National Mission for Clean Ganga- Development, Rehabilitation with  
Operation & Maintenance of STPs at Kanpur under Hybrid Annuity based PPP mode

**Sub: HAM KANPUR:** Inspection Report of 43 MLD Jajmau Phase 2, Inspection done on 30.03.2022

SITE INSPECTION REPORT FOR 43 MLD JAJMAU PHASE-II STP

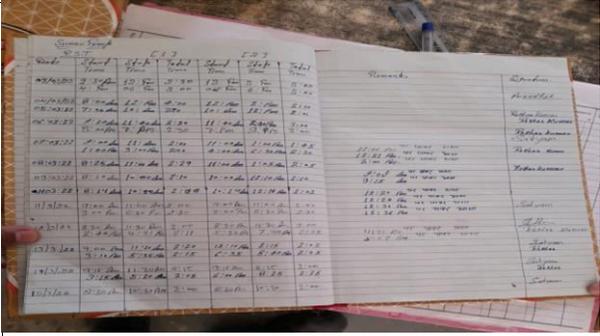
Decimal	DMS																	
Kanpur																			
Uttar Pradesh	Latitude 26.417707	26°25'3" N																	
India	Longitude 80.418173	80°25'5" E																	
3	Fine Screen No.3(Manual)	Opertaional	 <p>CC081447, Jajmau Sub Metro City, Kanpur, Uttar Pradesh 206009, India</p> <table border="1"> <thead> <tr> <th></th> <th>Decimal</th> <th>DMS</th> </tr> </thead> <tbody> <tr> <td>Kanpur</td> <td></td> <td></td> </tr> <tr> <td>Uttar Pradesh</td> <td>Latitude 26.417707</td> <td>26°25'3" N</td> </tr> <tr> <td>India</td> <td>Longitude 80.418173</td> <td>80°25'5" E</td> </tr> </tbody> </table> <p>2022-03-30(Wed) 02:42(pm)</p> <p>screen pannel</p>		Decimal	DMS	Kanpur			Uttar Pradesh	Latitude 26.417707	26°25'3" N	India	Longitude 80.418173	80°25'5" E		16.12.2021		Pending.
	Decimal	DMS																	
Kanpur																			
Uttar Pradesh	Latitude 26.417707	26°25'3" N																	
India	Longitude 80.418173	80°25'5" E
